AGENDA
HISTORIC DISTRICT COUNCIL
REGULAR MEETING -VIRTUAL
THURSDAY, SEPTEMBER 17, 2020
5:00 PM
CITY HALL COMMISSION CHAMBERS
204 ASH STREET
FERNANDINA BEACH, FL 32034

- 1. CALL TO ORDER / ROLL CALL / DETERMINATION OF QUORUM**
- 2. APPROVAL OF MEETING MINUTES**
- 3. OLD BUSINESS**
 - 3.1 HDC 2019-37 - MARK AKINS, RICE ARCHITECTS, AGENT FOR FIRST PRESBYTERIAN CHURCH OF FERNANDINA BEACH, 515 CENTRE STREET**
Certificate of Approval (COA) to renovate the south and east elevations and add a rooftop terrace with canopy. *(Quasi-Judicial)*

Owner/Applicant:	Rice Architect, agent for First Presbyterian Church Fernandina Beach
Property Address:	515 Centre Street
Requested action:	Certificate of Approval (COA) to renovate the south and east elevations and add a rooftop terrace with canopy.
Current zoning:	C-3
FLUM land use category:	Central Business District
Existing uses on the site:	Commercial
FL Master Site File #	8NA01098
Year Built:	1957 (FMSF)
Contributing Status:	Non-Contributing

Updated Plans & Elevations

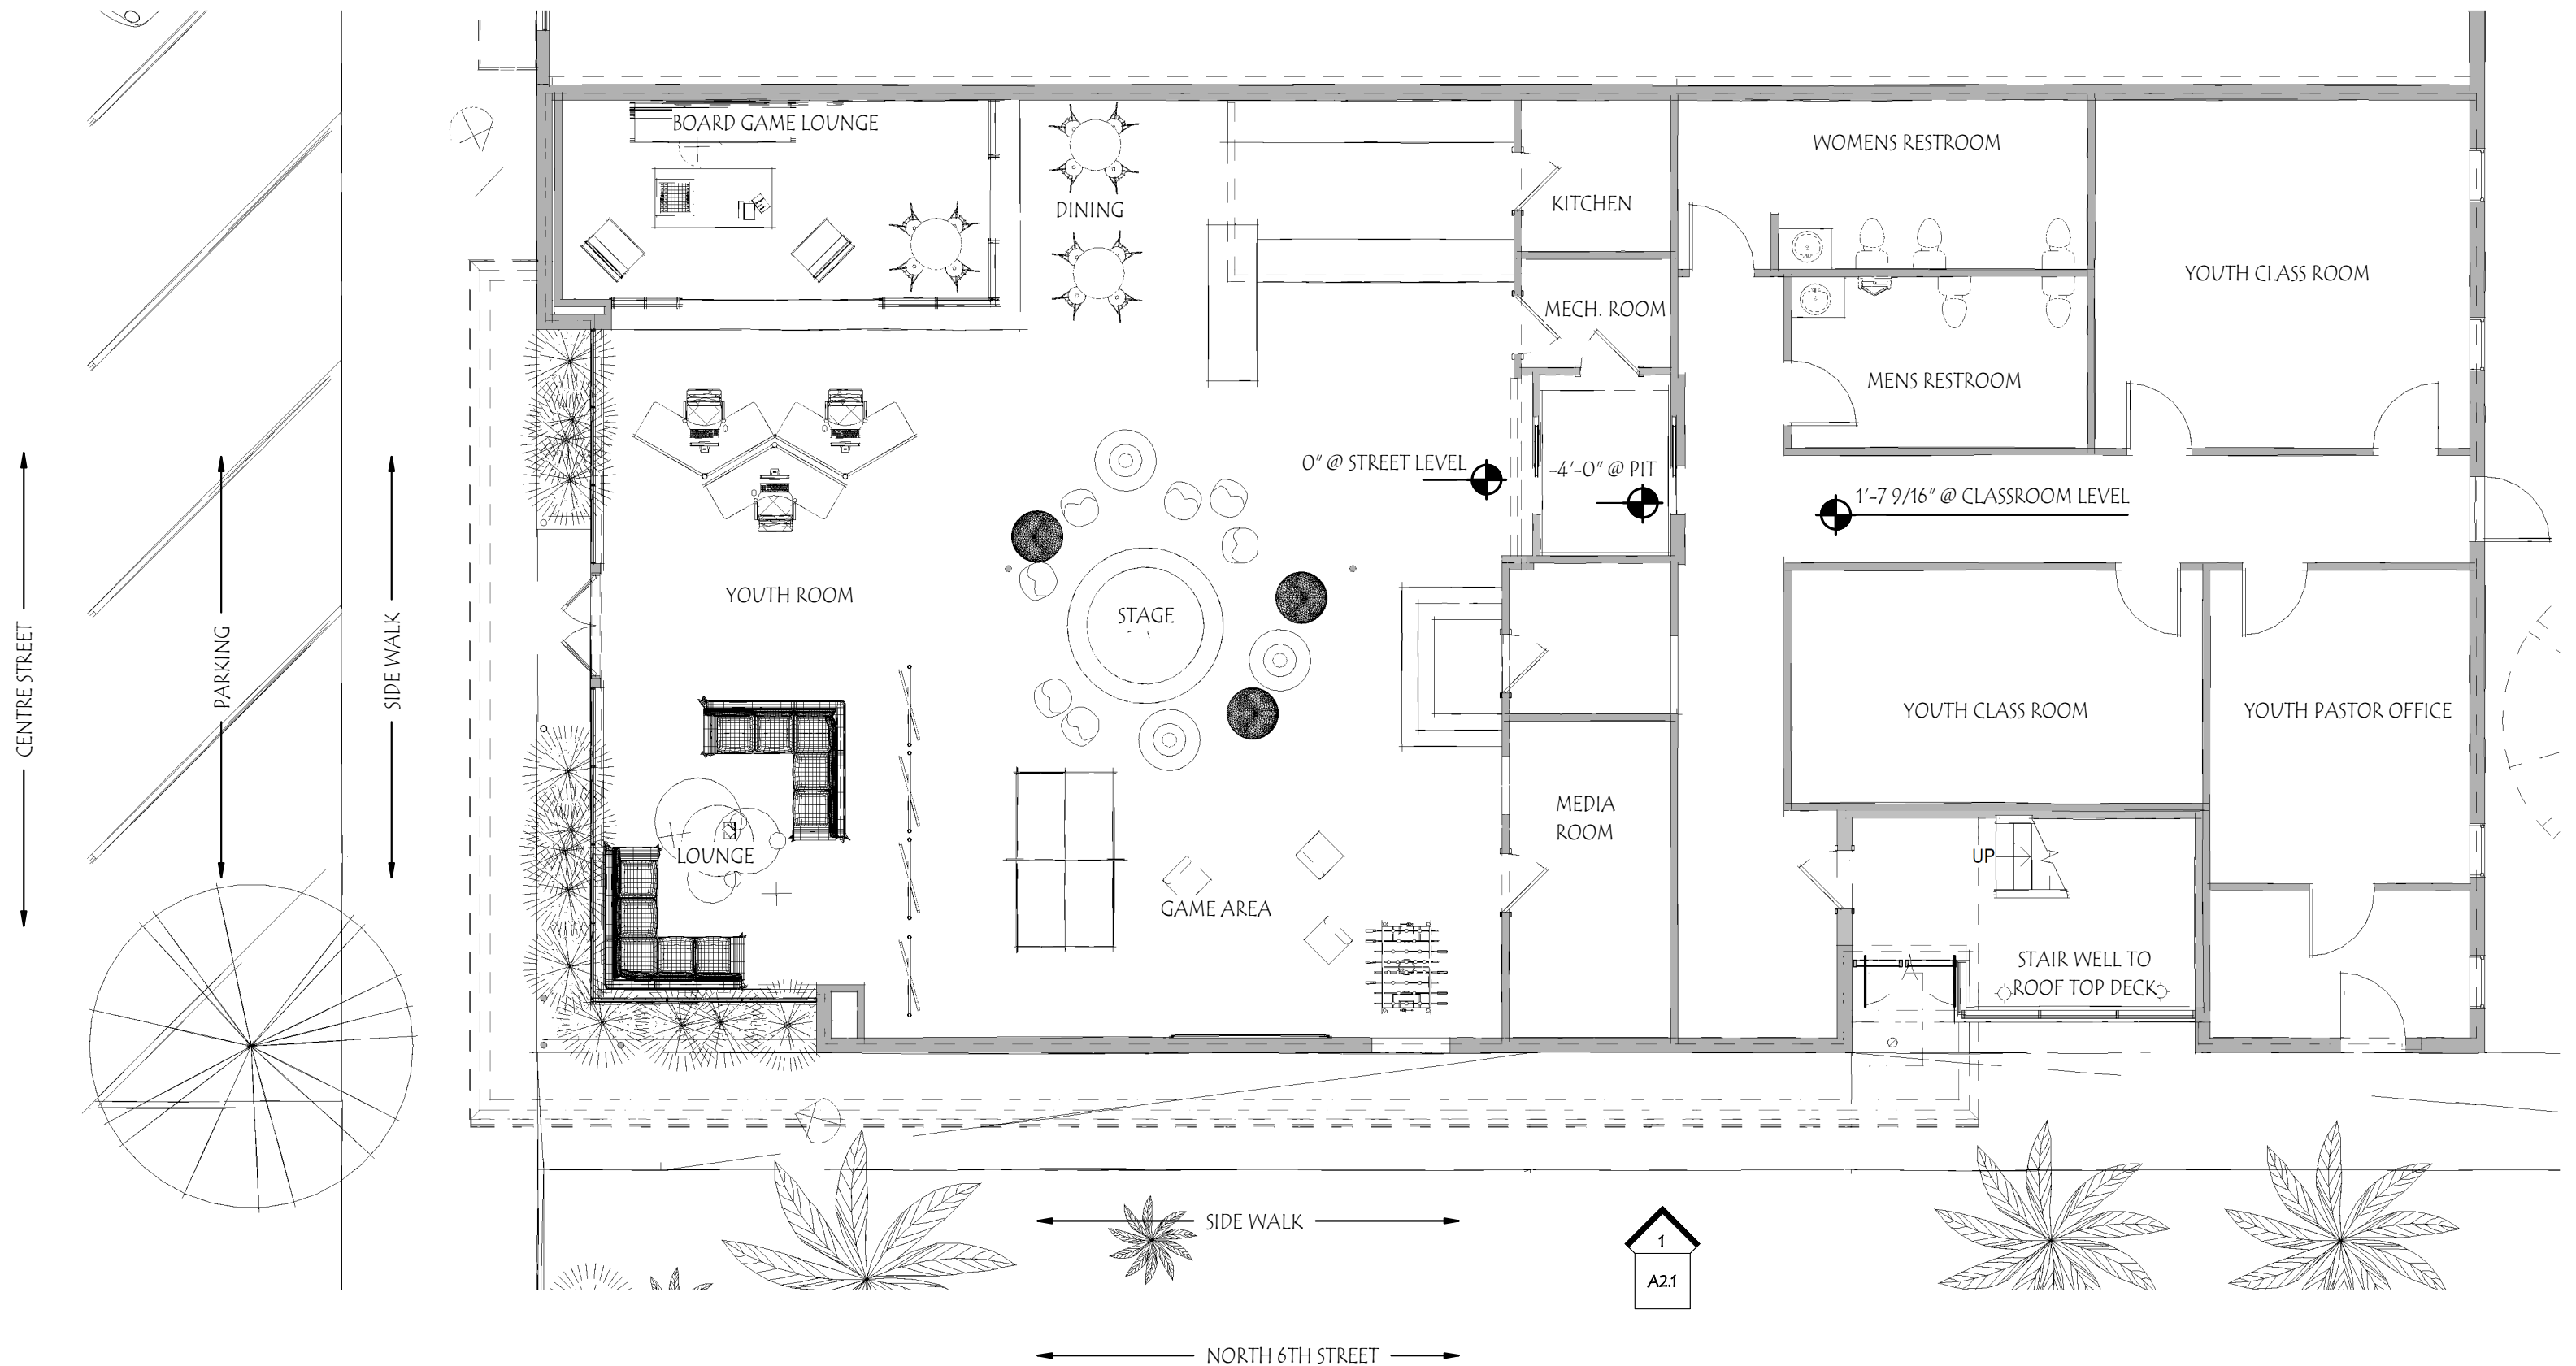
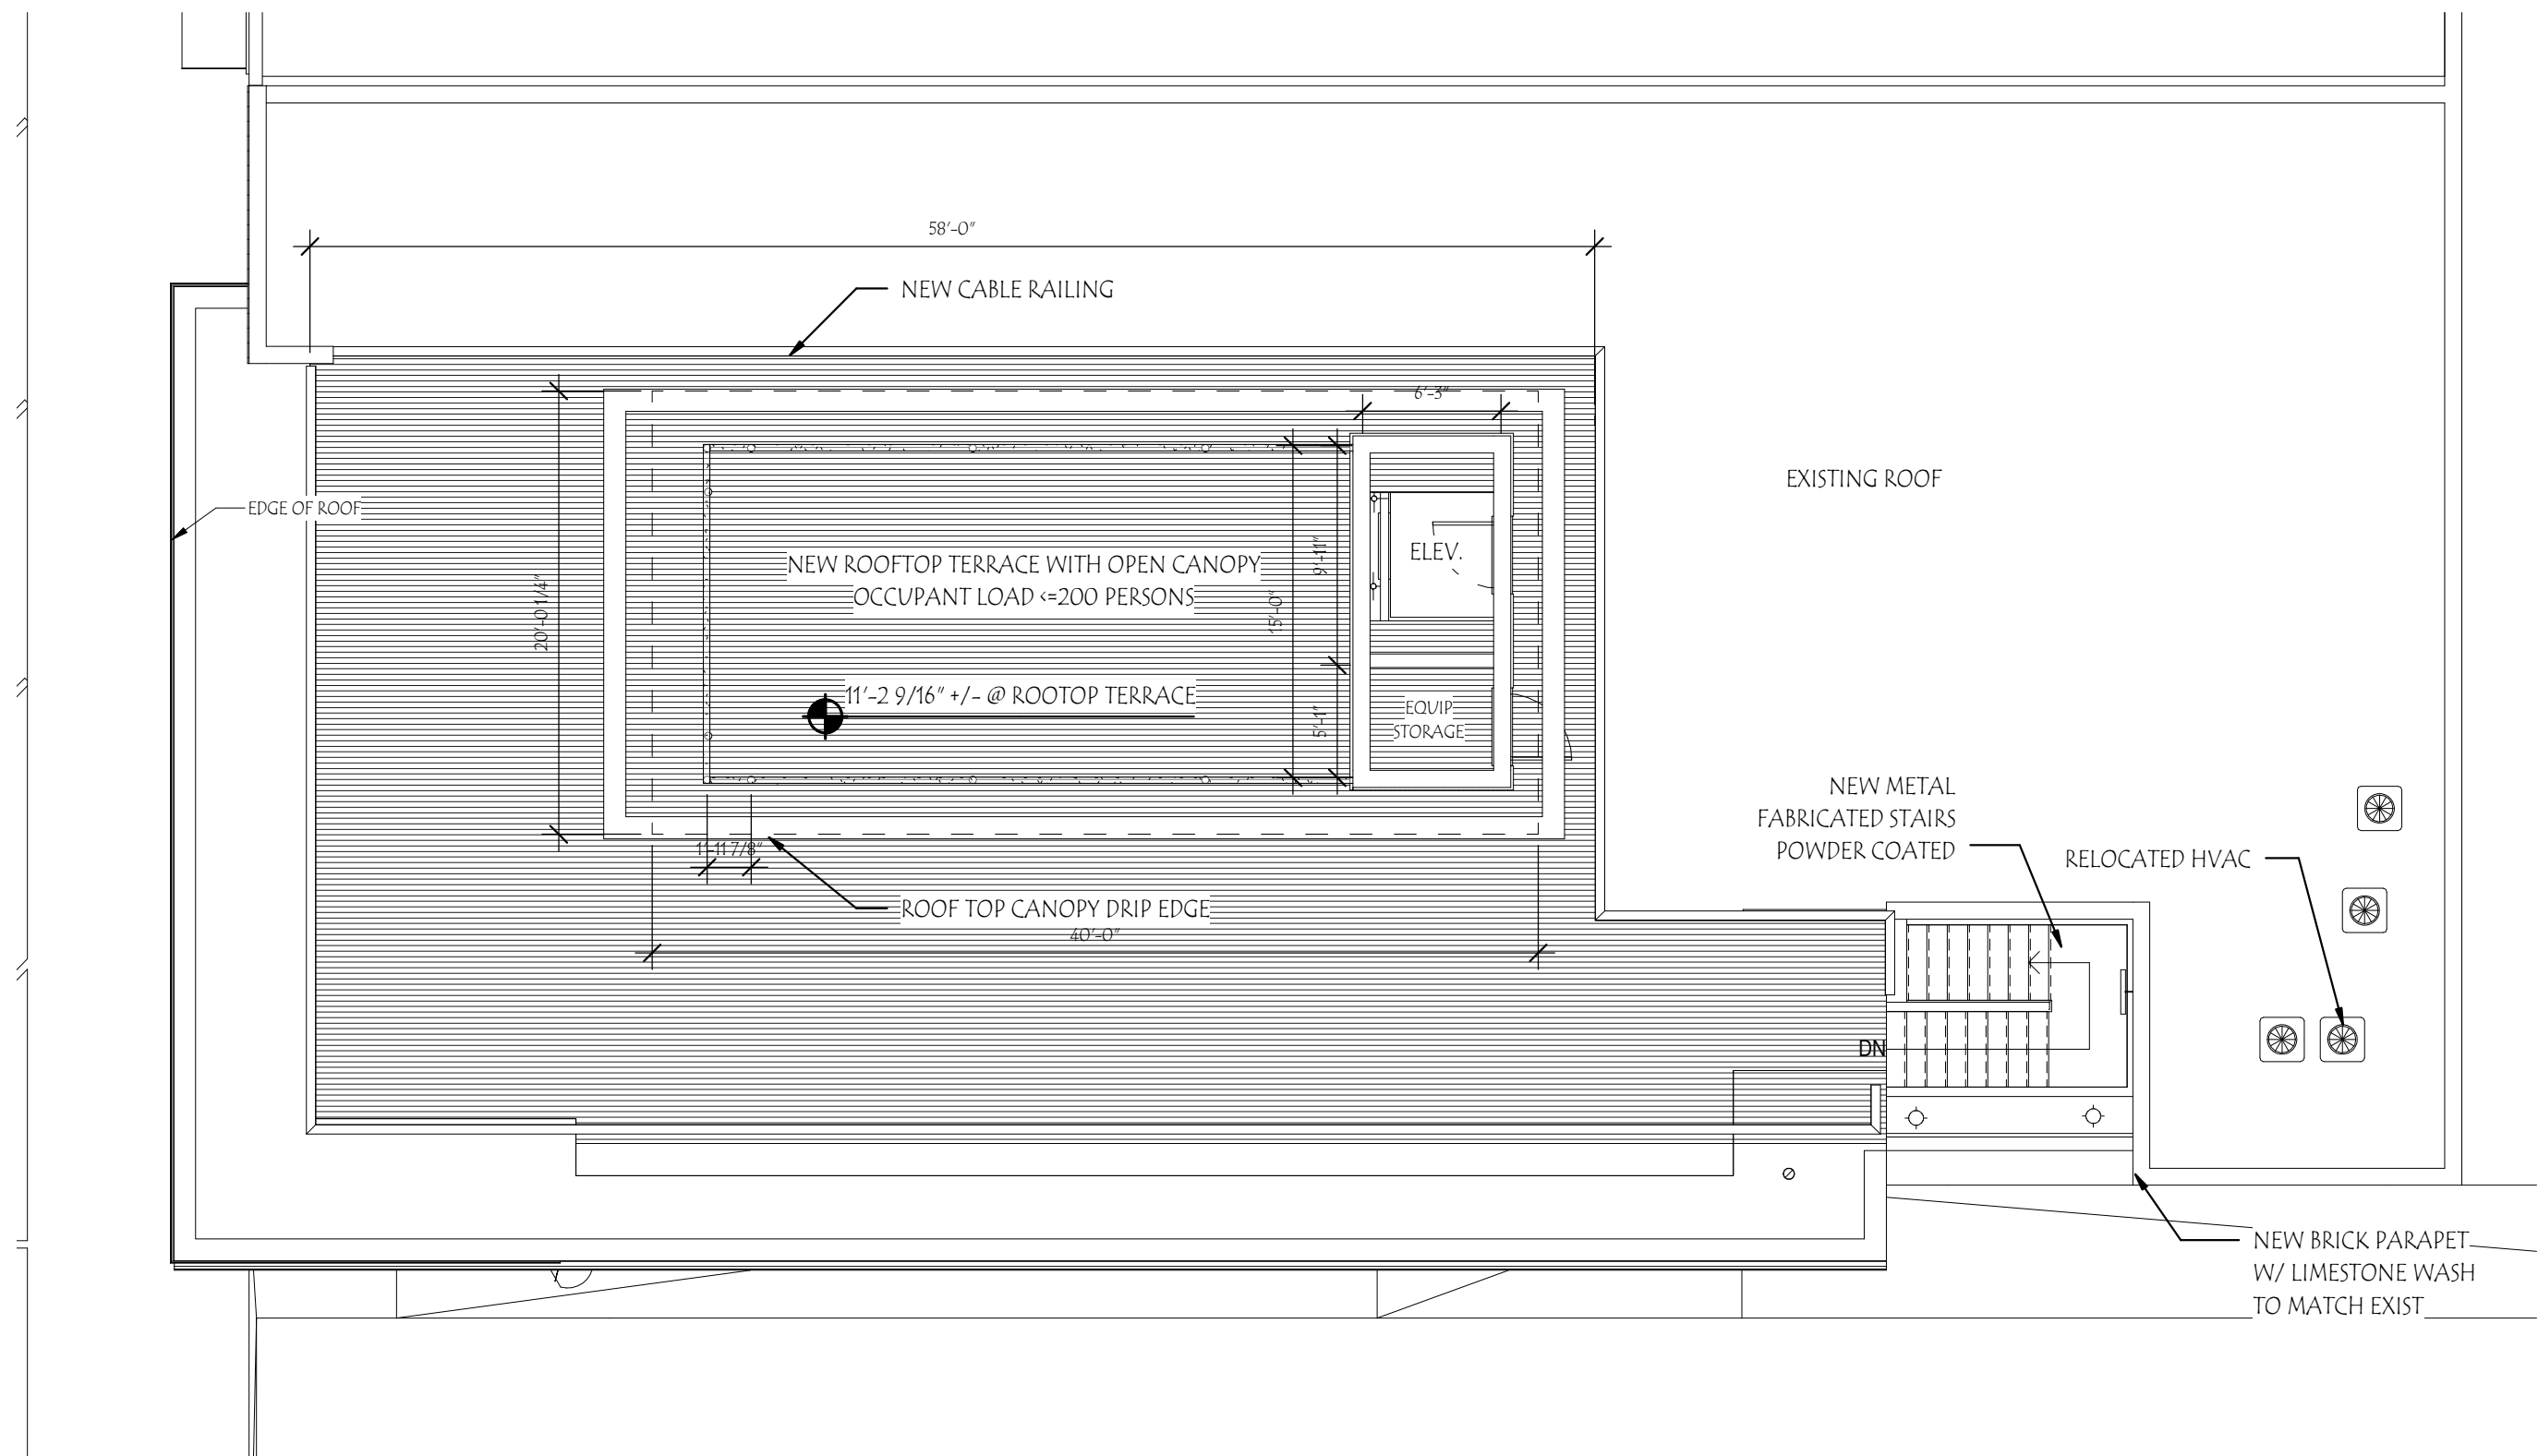
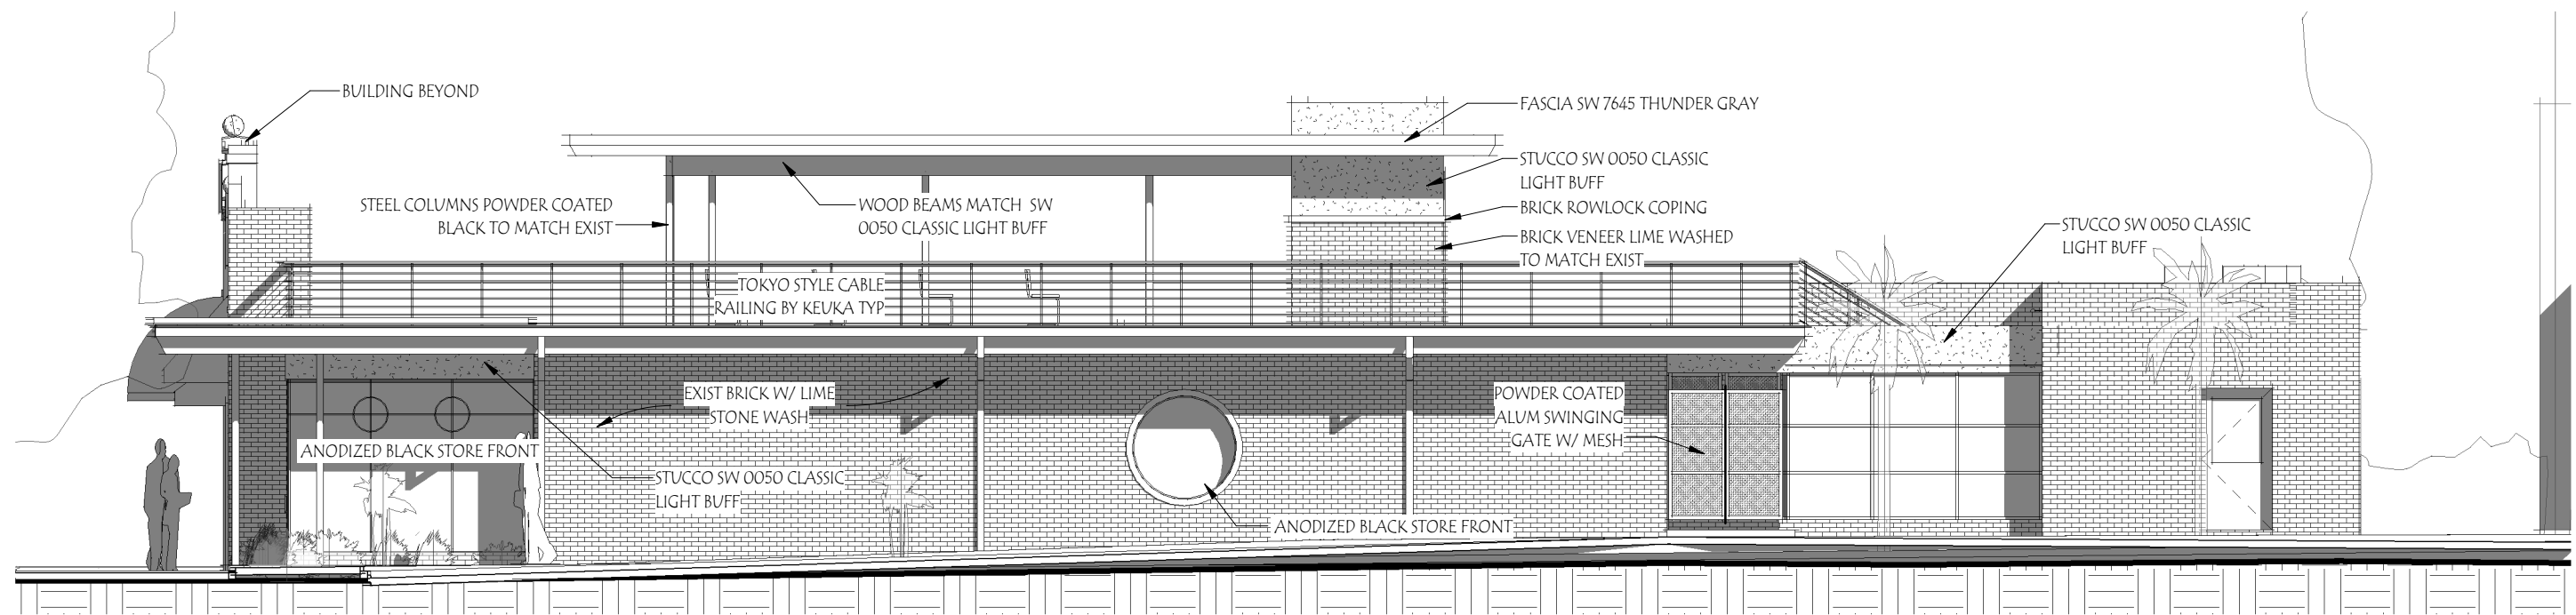
Staff is concerned that the level of alterations being proposed undermine the structures historic integrity. Many elements are being added to the structure which do not have any basis in the original design, which featured simple lines and emphasis on the horizontality. Utilizing the rooftop is allowable, but the proposed canopy does not relate to the architecture of the building and will be highly visible from multiple sides of the building. As designed, the rooftop canopy will be a visual detractor to the building and the district as a whole.

1. Elimination of the reflecting pond and railings at front entrance;
2. Reduction to the number of circular windows on the east elevation from three to one larger one;
3. Change in roof form of rooftop canopy from hipped to flat roof; and
4. Change in rooftop railing design.
